Dragonclaw v0.2 1.8V Load Switch Rework

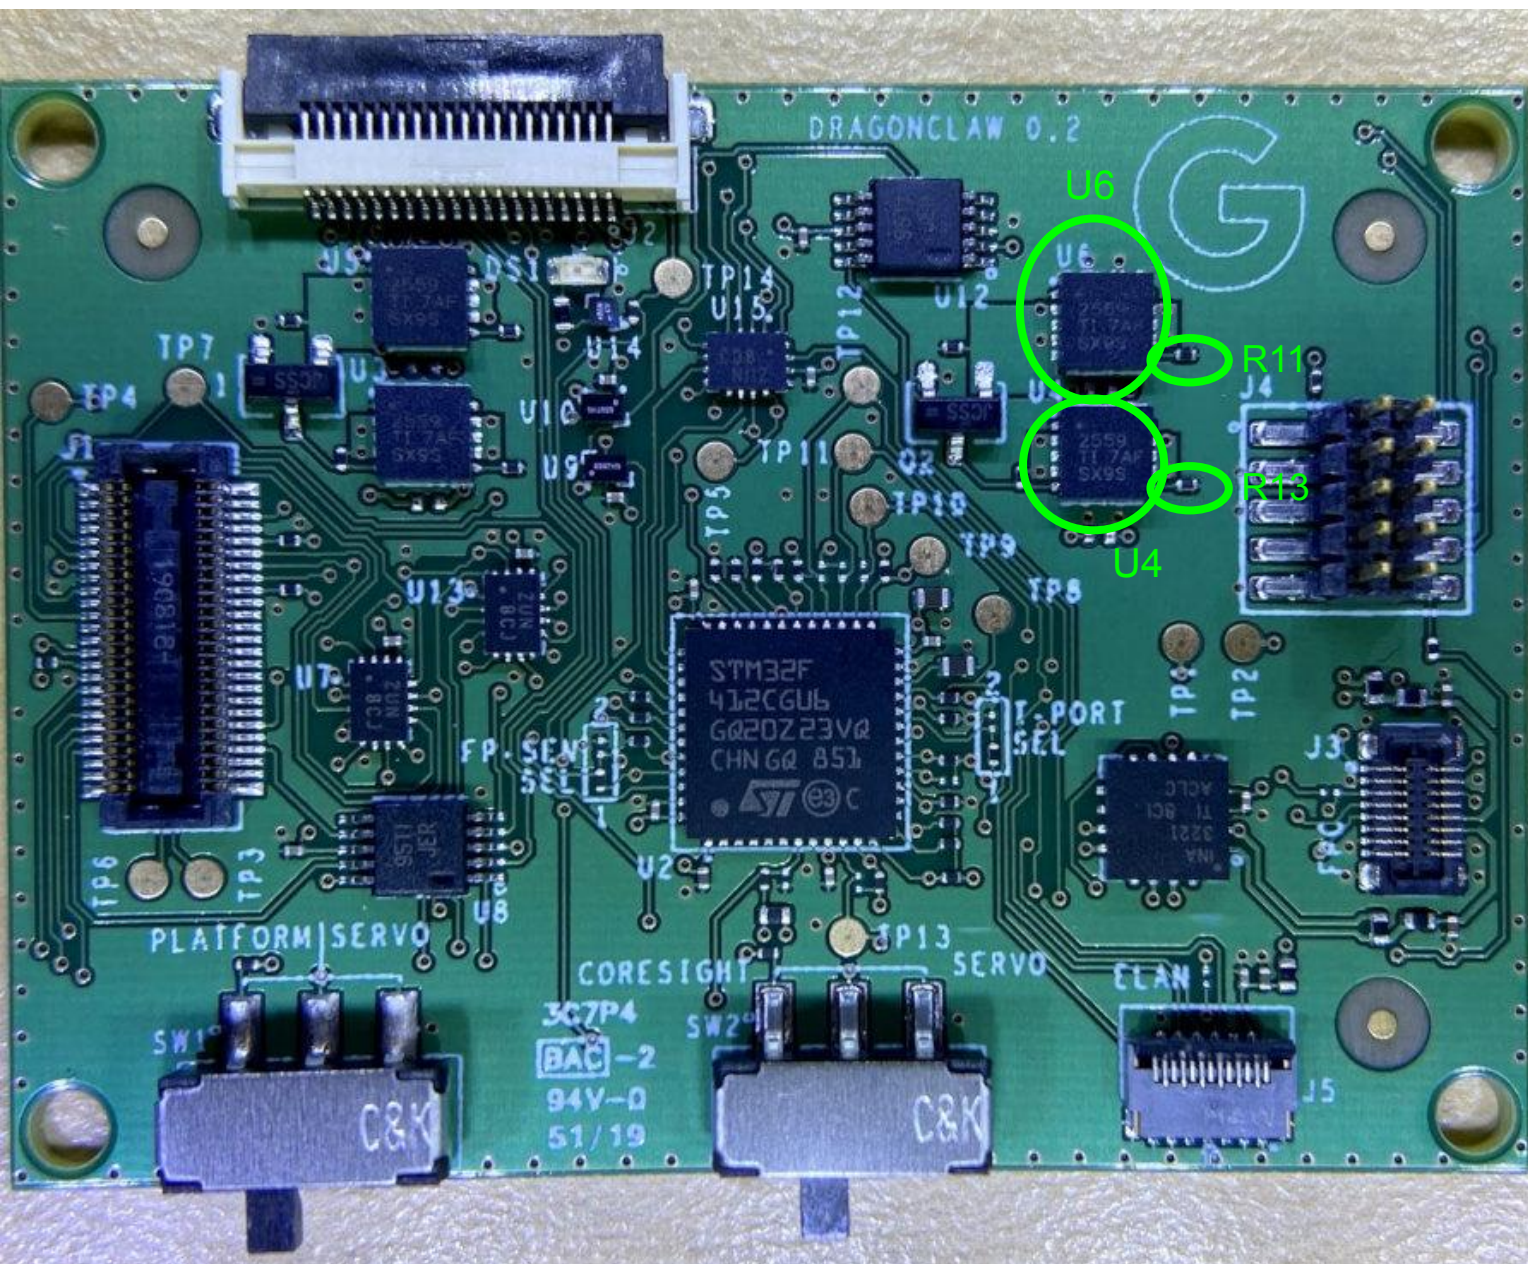
Remove U6 and U4. Replace with FPF2125.

Right-align FPF2125 with existing footprint.

V_{out} and Iset line up with the right side pads.

GND lines up with the center ground pad.

Lift up the V_{in} and ON legs and use small wire to connect it to the left pads.

Replace R11 and R13 with 10K Ω resistors.
